MILITARY SPECIFICATION SHEET

CABLES, RADIO FREQUENCY, FLEXIBLE, COAXIAL,
50 OHMS, M17/060-RG142

This amendment forms a part of Military Specification Sheet MIL-C-17/60C, dated 15 March 1977, and is approved for use by all Departments and Agencies of the Department of Defense.

FIGURE 2. Power rating and attenuation.

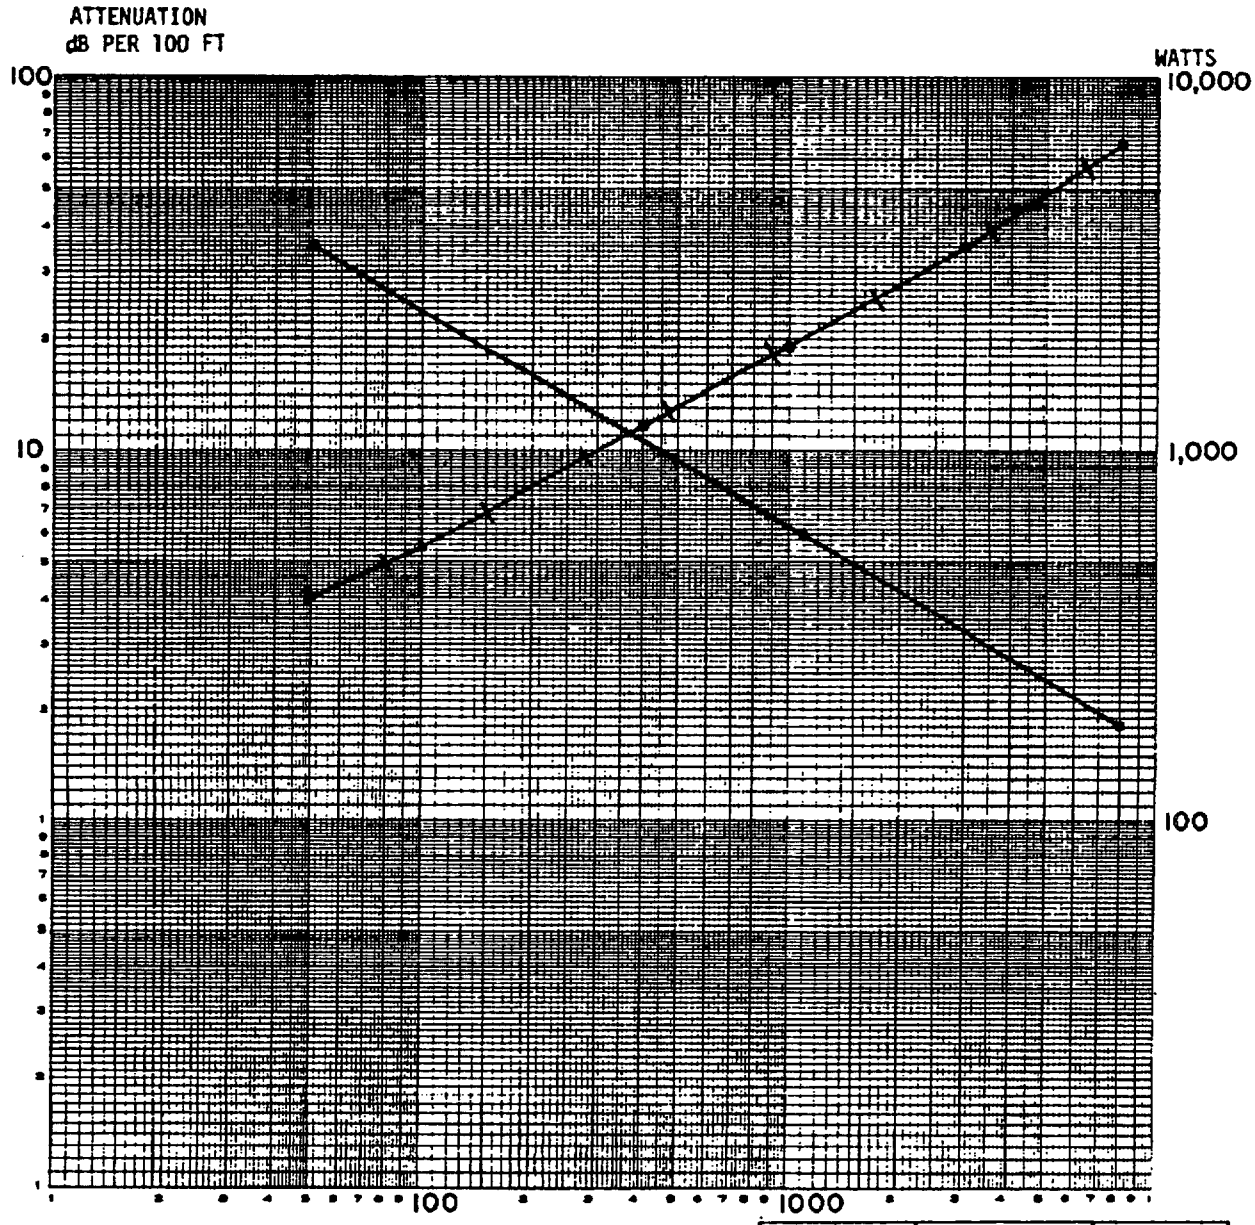
Delete and substitute figures 2 and 3 as printed on pages 2 and 3 of this amendment.
